**3600@Villard**  
3600 W. Villard Avenue  
Milwaukee, WI 53209

Submittal for Minor Modification to the Detailed Plan Development  
Original File Number: 160917  
Submitted: December 21, 2016

New File Number: 181488  
Submitted: February 11, 2019  
Updated: February 13, 2019

## Owner's Statement of Intent for a Minor Modification

Architectural: Building Elevations + Sections - Modification #181488

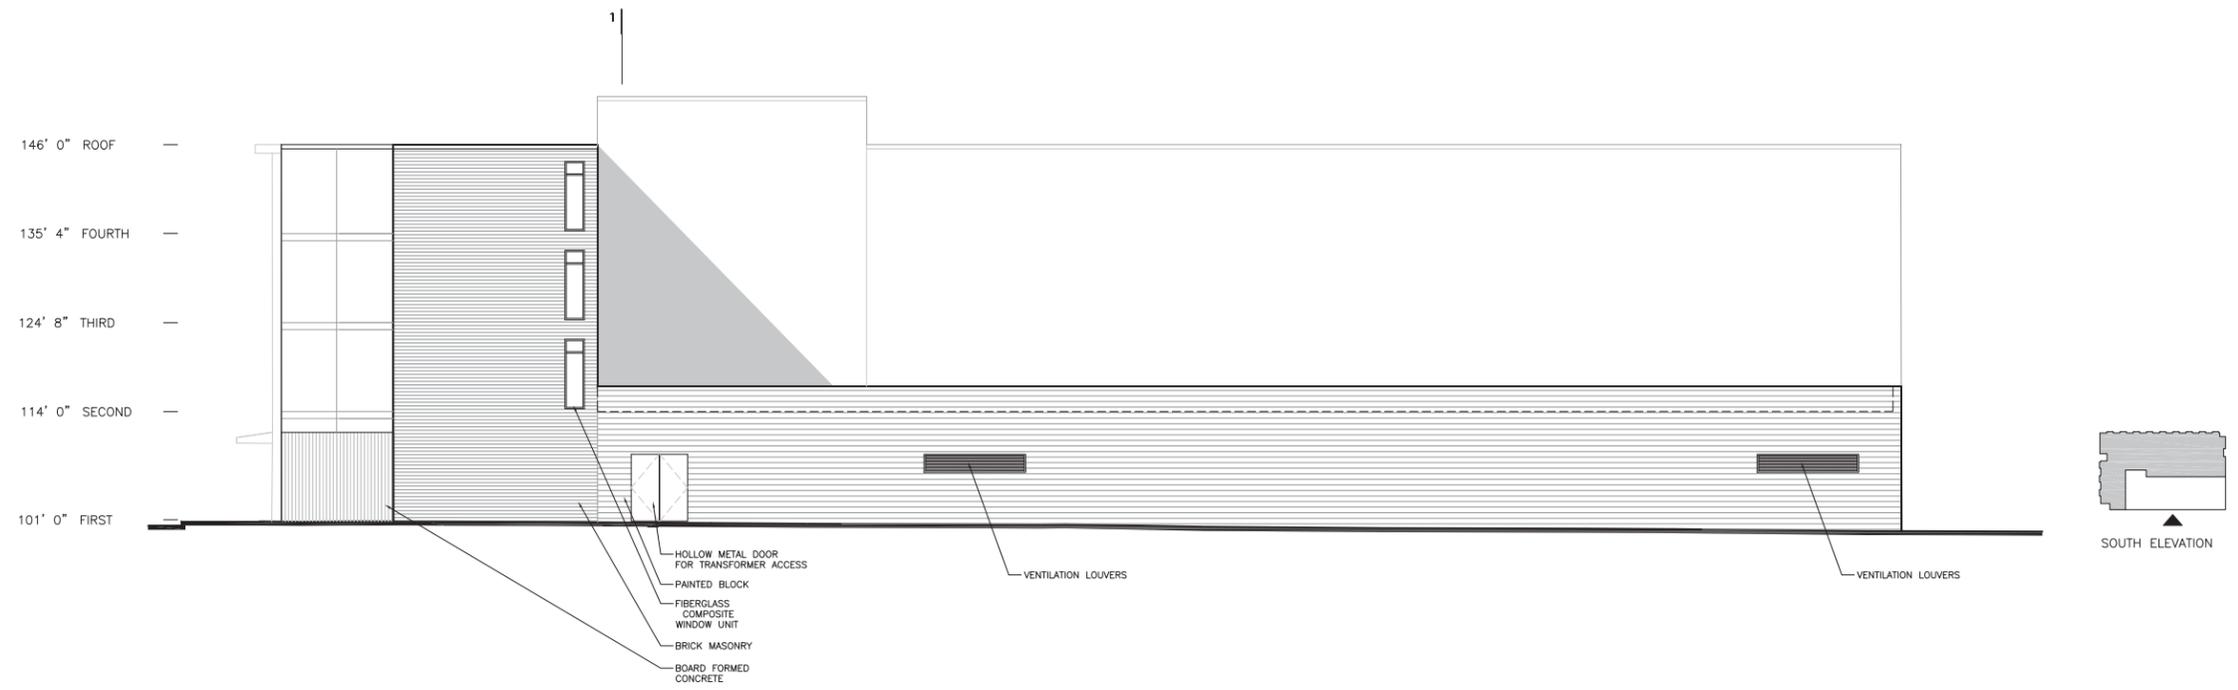
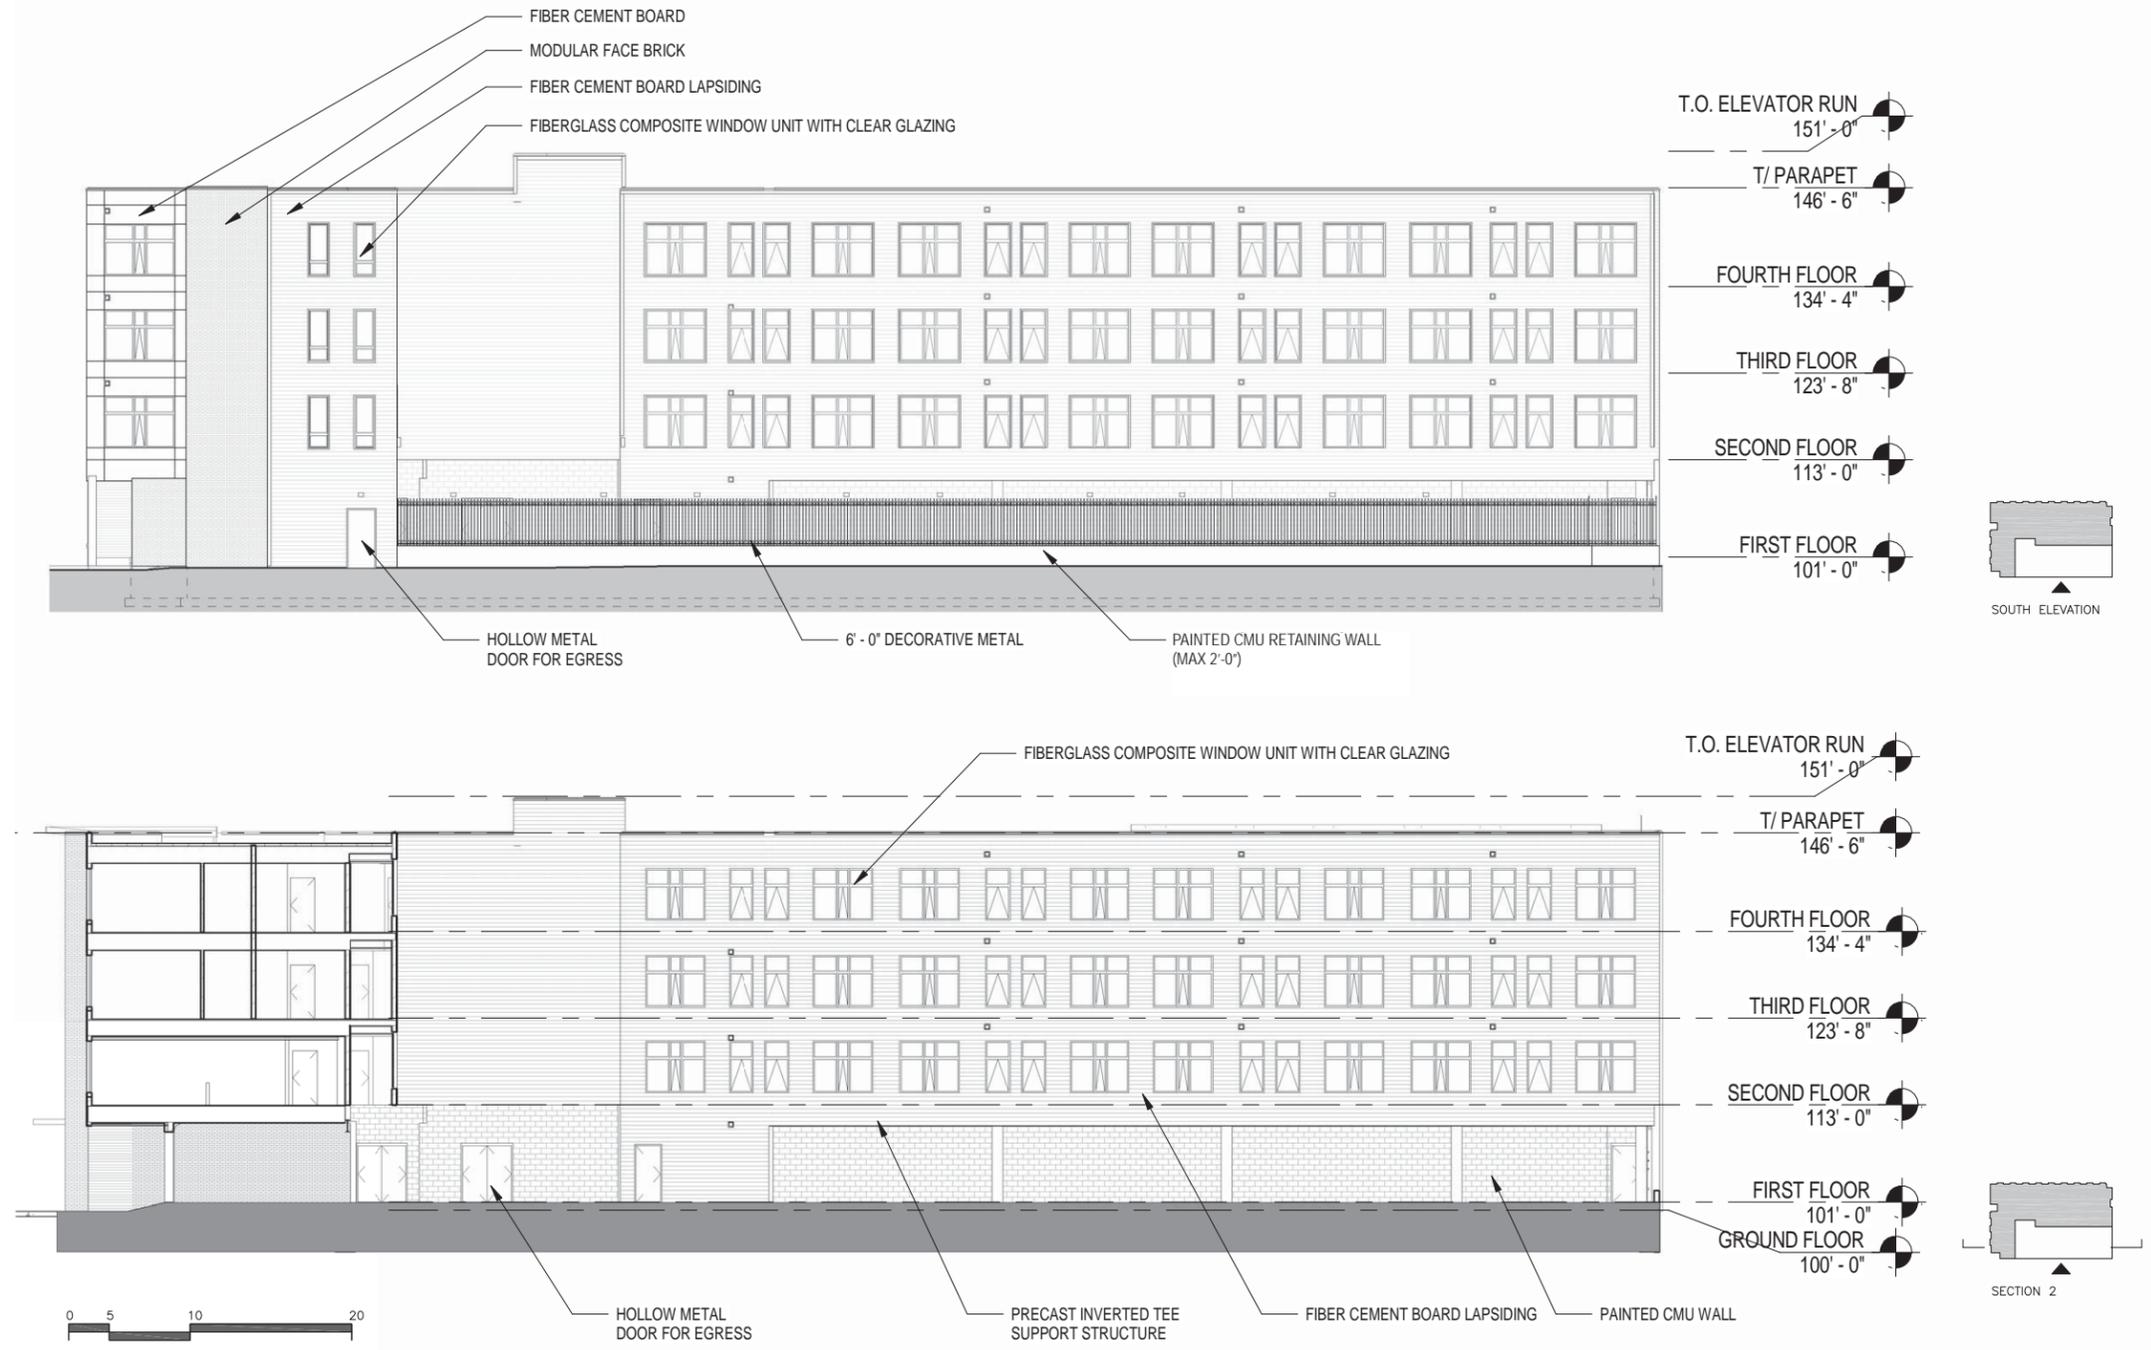
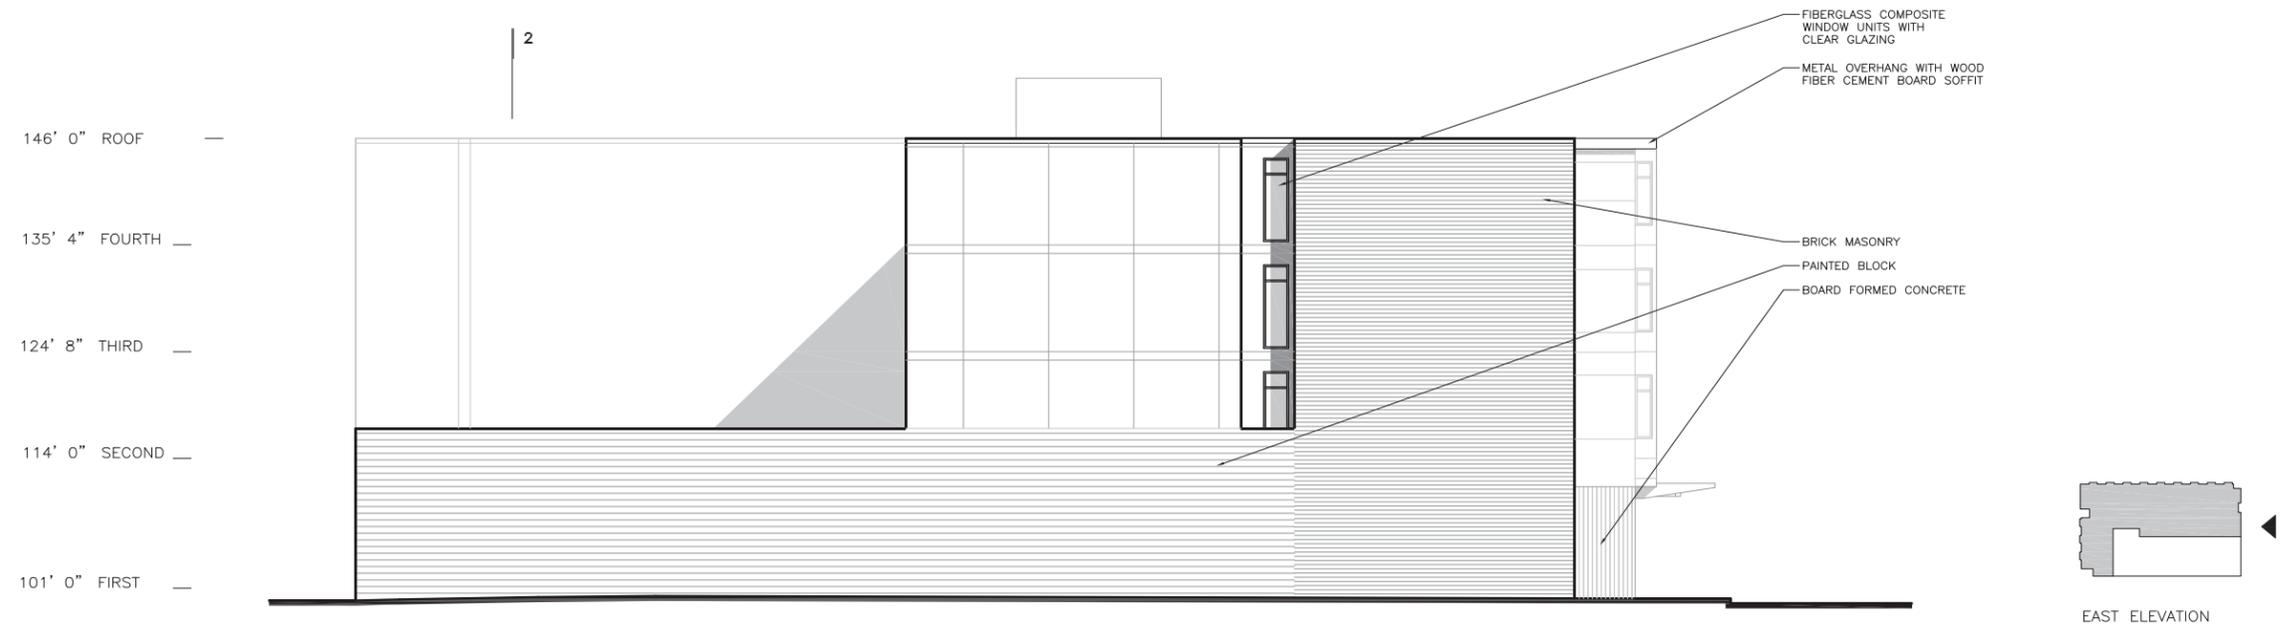
A Detailed Plan Development (DPD) was approved on January 18, 2017 (#160597). It approved a four-story, 43-unit, mixed-use building with enclosed parking at the back of the property. As the design was further refined, the applicant is requesting that the previous enclosed parking become a surface parking lot. The painted concrete masonry unit wall at the south and east facades enclosing the parking will be removed from the project. The amenity deck, once on the roof of the enclosed parking, will be removed from the project. The surface parking lot will be enclosed with a maximum 2'-0" high painted concrete masonry unit retaining wall topped with a 6'-0" decorative metal fence. The previously approved DPD included up to 26 parking spaces. The transformer will be located outside on a concrete pad at the south east corner of the site. The modified surface parking will include up to 27 spaces. The parking will be illuminated with wall mounted lighting on the south and east facades of the building. Light poles may be added along the fence line as needed. The street facades will remain unchanged and parking access will remain from the overhead door at the west side of the building. The trash collection will remain enclosed within the building. The bicycle parking will be moved to enclosed within the building.
